A REPAIR

ON-SITE SEWAGE DISPOSAL SYSTEM HOWARD COUNTY HEALTH DEPARTMENT BUREAU OF ENVIRONMENTAL HEALTH

05-354374

ADDRESS: 7606 Browns Bridge Road PROPERTY OWNER: John Rogers

P520010

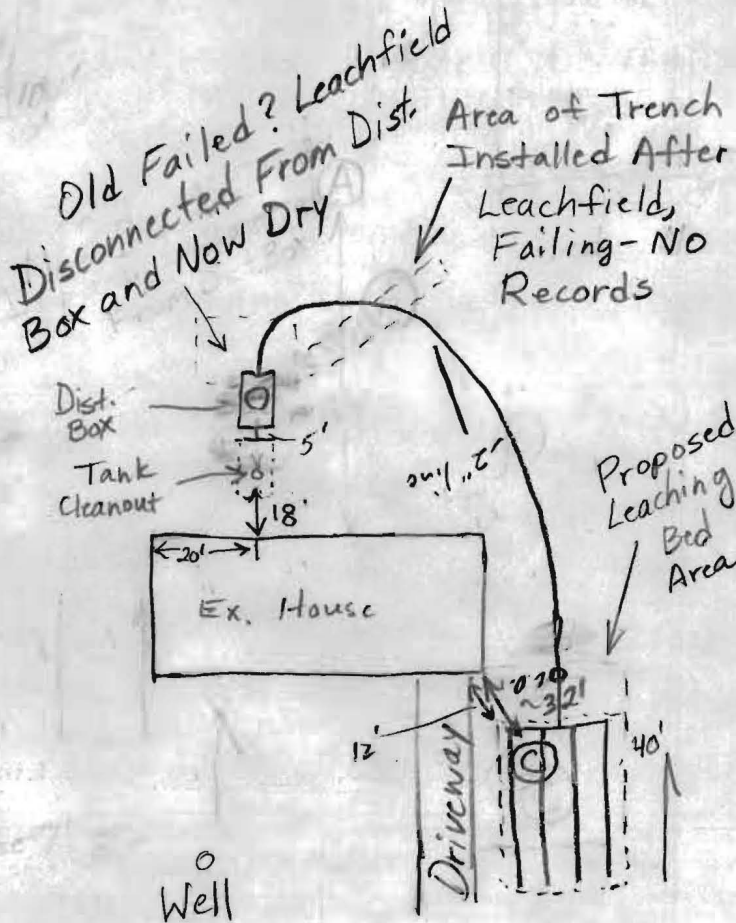
*Bed to have 1 foot
of stone and enough to
cover laterals*

TRENCHES:	Trench to be _____ feet wide. Inlet _____ feet below original grade. Bottom maximum depth _____ feet below original grade. Effective area begins at _____ feet below original grade. _____ feet of stone below distribution pipe.
LOCATION:	
PURPOSE:	Septic system is failing. Call for inspection when the ground has been opened so sanitarian can recommend repair.

PRE-CONSTRUCTION 1/6/04 To install pump tank after existing tank and pump to area near test hole (C). To install and pump INSTALLATION to a 20'x40' leachbed with a maximum bottom depth of 8' at the downhill part of the bed that will be parallel to the front of the house. Keep the bottom of the bed level (will be deeper than 8' uphill). Should be enough room for one more bed uphill of the proposed bed if a future repair is needed. (BB) 3/3/04 - P.T. set leaching bed installed. OK to cover. Pump & Alarm needed (SO) 3/15/04 - Pump & Alarm OK (SO)

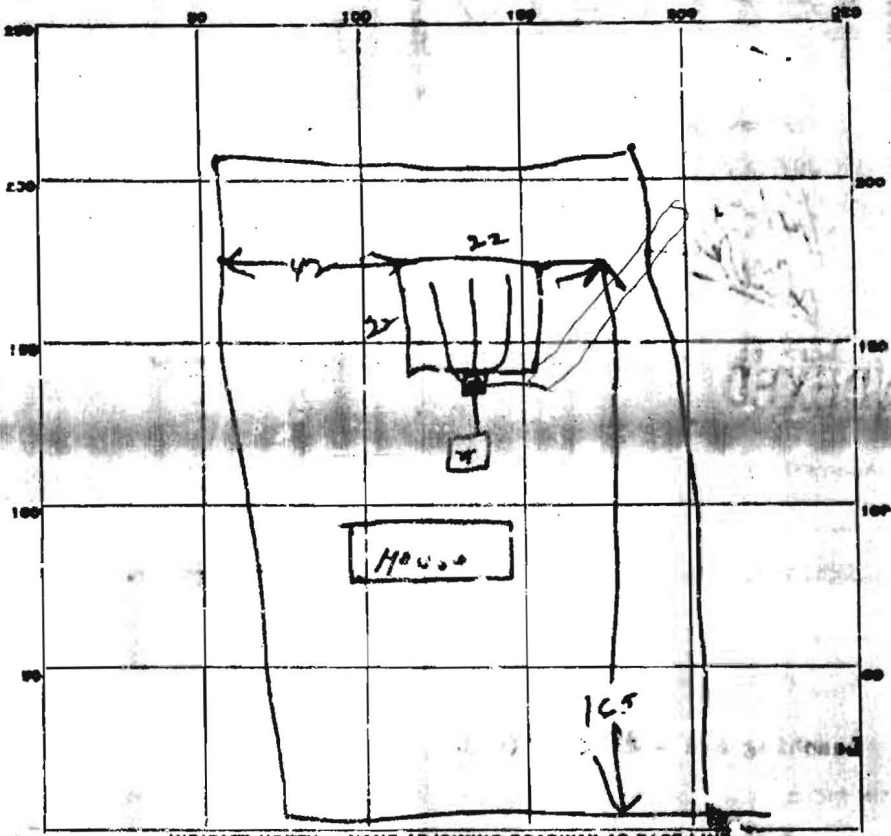
REMARKS 5/14/63 - need cleanout pipe or septic tank inlet pipe to
septic tank not yet installed. need baffle for dist. box. Paper needs to
be installed over leading end of DM
5-17-63 Work item done

High Water Table
Behind House.

Leach bed to have
stone from 7'-8'
in downhill part. Can
be deeper uphill so
that bottom is level.
